## **Alternative Physical Security Requirements for Advanced Reactors Proposed Rule: DIFFERING VIEW**

An Office of Nuclear Security and Incident Response (NSIR) staff member provided a differing view with four problem statements on the proposed rule. The staff member's differing view arises from the proposed provisions within Title 10 of the *Code of Federal Regulations* (10 CFR) 73.55(s)(1)(ii), "Eligibility," where "[t]he applicant or licensee must demonstrate that the consequences of a postulated radiological release that results from a postulated security-initiated event do not exceed the offsite dose reference values defined in §§ 50.34 and 52.79 of this chapter," and 10 CFR 73.55(s)(1)(iv), "Analysis," where "[t]he applicant or licensee electing to meet one or more of the alternative security requirements in paragraph (s)(2) of this section must perform a technical analysis demonstrating how it meets the criteria in paragraph (s)(1)(ii) of this section." The differing view is characterized in the following problem statements:

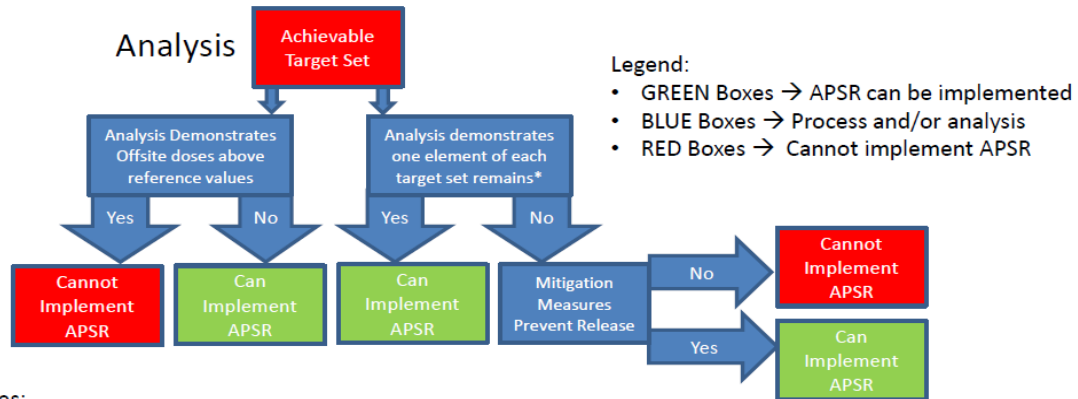
Unlike the current safety and security regulatory framework, the implementation of the proposed rule requires that an analysis be performed to evaluate potential offsite consequences based on a consequence threshold of 25 rem TEDE, including additional analysis of DBT-initiated scenarios. This requirement, illustrated below, was presented in public meetings on October 19, 2021 (Agencywide Documents Access and Management System (ADAMS) Accession No. ML21291A238), and January 20, 2022 (ADAMS Accession No. ML22019A075).

Under the current regulations and regulatory framework, the licensee or applicant uses 25 rem TEDE as the reference value in its analyses, assessments, and evaluations to identify the necessary design features, SSCs, and barriers. For example, compliance with 10 CFR 50.34(a)(1)(ii) and 10 CFR 50.34(a)(1)(ii)(D) or with 10 CFR 52.79(a)(1)(vi) and 10 CFR 52.79(a)(2) means that, crediting the safety functions of plant features, SSCs, and barriers identified, the postulated fission product release (using the expected demonstrable containment leak rate and any fission product cleanup systems intended to mitigate accident consequences) would not lead to a radiation dose above 25 rem TEDE. The current requirements of 10 CFR 73.55, when met and acceptably implemented, provide adequate protection to ensure maintenance of the safety basis as analyzed and documented in the final safety analysis report. The current regulations and regulatory framework for the safety/security interface make it unnecessary to require an analysis within the framework of 10 CFR 73.55; doing so would impose an arbitrary applicability requirement (or eligibility condition) on licensees wishing to apply the alternatives in 10 CFR 73.55(s)(2) in their designs. The differing view problem statement asks why the consequence analysis requirement in the proposed rule is necessary.

Furthermore, the analysis required by 10 CFR 73.55(s)(1)(ii) and 10 CFR 73.55(s)(1)(iv), as shown in the figure above, will allow a licensee or applicant to undermine the current safety and security regulatory framework. Specifically, a licensee or applicant could evaluate the potential offsite consequences of a loss of identified design features, SSCs, or barriers (e.g., those identified through safety analysis, assessments, and evaluations using reference values, the DBA, etc.) due to a DBT-initiated event, based on availability of mitigation equipment and ability to move freely to perform mitigation to prevent release up to an offsite dose of 25 rem TEDE. By establishing a provision in 10 CFR 73.55 that allows for reliance on mitigation measures (human actions) to prevent release, the NRC would enable licensees and applicants to intentionally erode current safety and security standards. Problem Statements No. 2 and No. 3 of this enclosure address this point in more detail.

## **Preliminary Proposed Rule Language**

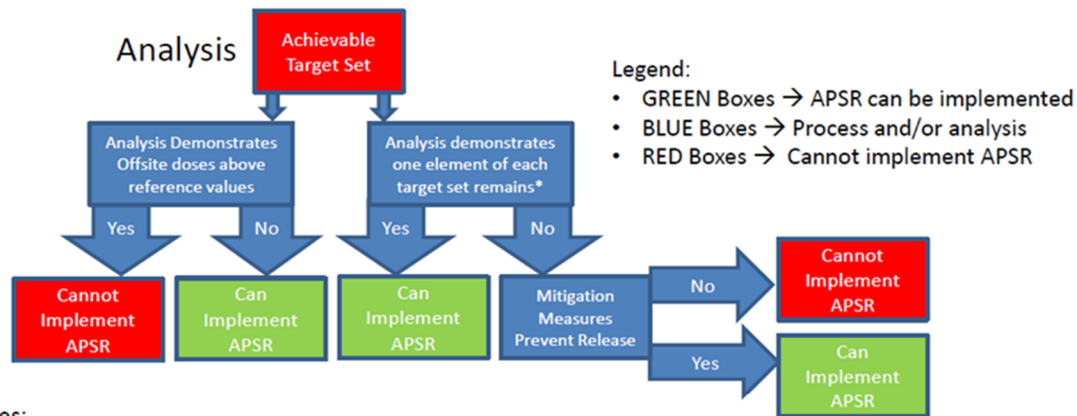
As stated earlier, this illustration was presented during public meetings on October 19, 2021, and January 20, 2022. It shows how the implementation of the proposed rule would allow for a licensee or applicant, through analysis performed under the proposed rule, to substitute mitigation measures relying on human actions for plant features, SSCs, and barriers identified through safety analyses, assessments, and evaluations in the safety and design bases. For example, under the proposed rule, the SSCs and barriers maintaining core cooling or containment integrity and spent fuel cooling or spent fuel pool integrity may be eliminated if analysis shows that mitigation measures can prevent any release resulting in a dose above 25 rem TEDE.

In addition, the illustration shows how the proposed rule undermines the current safety and security regulatory framework by allowing a licensee or applicant to downgrade the categorization, and the associated treatment, of SSCs and barriers based on 10 CFR 50.69. That is, under the proposed rule, a licensee or applicant may show that with mitigation measures, the failure of certain SSCs and barriers that are currently classified as RISC-1 or RISC-2 (or whose failure would lead to common-cause failure of RISC-1 or RISC-2 SSCs) would result in offsite release of no more than 25 rem TEDE. The licensee could then reclassify these SSCs and barriers as RISC-3 or RISC-4 or eliminate them altogether, considering them unnecessary for ensuring low risk of offsite release, although they are considered necessary under current design requirements for safety.

In relation to the safety/security interface, the implementation of the proposed rule allows the licensee or applicant to use a consequence analysis, based on consequences mitigated by reliance on human actions, to justify reducing the plant security posture, eliminating the protection of SSCs and barriers that otherwise would have been identified as target set equipment and protected by the design of the physical protection program. It should be noted that mitigation measures would be applied within a defense-in-depth strategy, to provide sufficient margin in safety and security designs to account for the uncertainties in the risk of public exposure to radiation resulting from design-basis accidents and beyond-design-basis events (e.g., aircraft impacts, Fukushima Dai-ichi event, and the DBT of radiological sabotage).
